## SCADA Clarifications Letter Tender No. (SELCo. 04/2019)

Kindly find below following questions received from companies and kindly find below our clarifications are in red:

- **S.G/Schneider-Relay :SEPAM T42:**

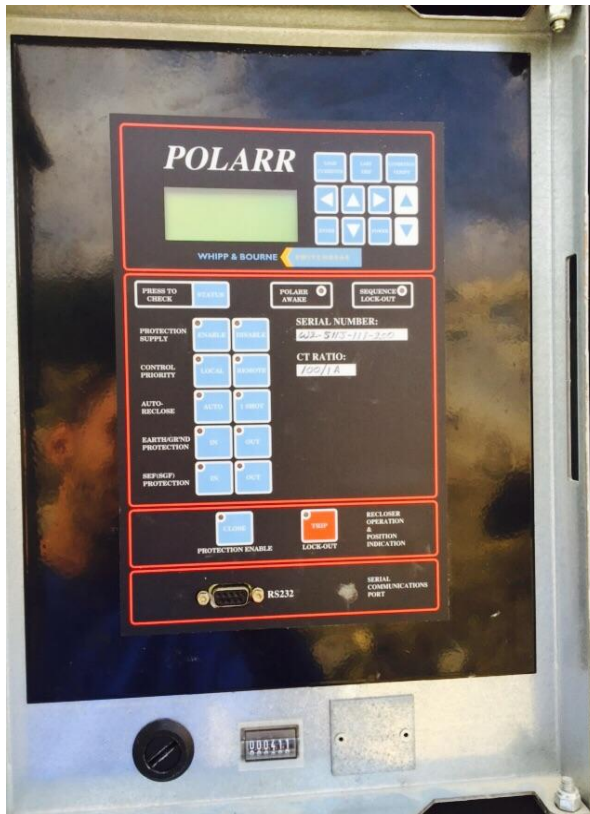
7- Please advise for the types of Autoreclosers that you use in your network and the quantities of each type that you want to control it via SCADA?

- We need the technical details about each site to define the signal lists, to see the number of switchgears and number of it?

- Type of each relay in each site?

No.	Site Name	Location	Switch Gear (S.G) Type Autorecloser (A.R) Type	Relay Type
1	Yatta connection point	Yatta	S.G/Schneider SM6-36	SEPAM T42
2	Yatta Al mahajer	Yatta	A.R/GVR	POLARR
3	Yatta Al Namaa	Yatta	A.R/GVR	POLARR
4	Yatta Al Balad	Yatta	A.R/GVR	POLARR
5	Mnizel Connection Point	Yatta	S.G/Ulusoy	SEPAM T42

6	AL Dhaheria connection point	Dhaheria	A.R/Entec	EVRC2A-NT
7	AL Dhaheria Al Merzab	Dhaheria	A.R/GVR	POLARR
8	AL Dhaheria Ishbilia	Dhaheria	A.R/GVR	POLARR
9	Dura connection point	Dura	A.R/Entec	EVRC2A-NT
10	Dura Sinjer	Dura	A.R/GVR	POLARR
11	Dura basatin	Dura	A.R/GVR	POLARR
12	Sekka Connection Point	West Dura	S.G/Schneider SM6-36	SEPAM T20
13	Bait mersem Connection Point	West Dura	S.G/Normafix	ISEG- MRI3
14	Ramadin Connection Point	Ramadin	A.R/GVR	POLARR
15	Abda-Imreish Connection Point	Dura	A.R/GVR	POLARR
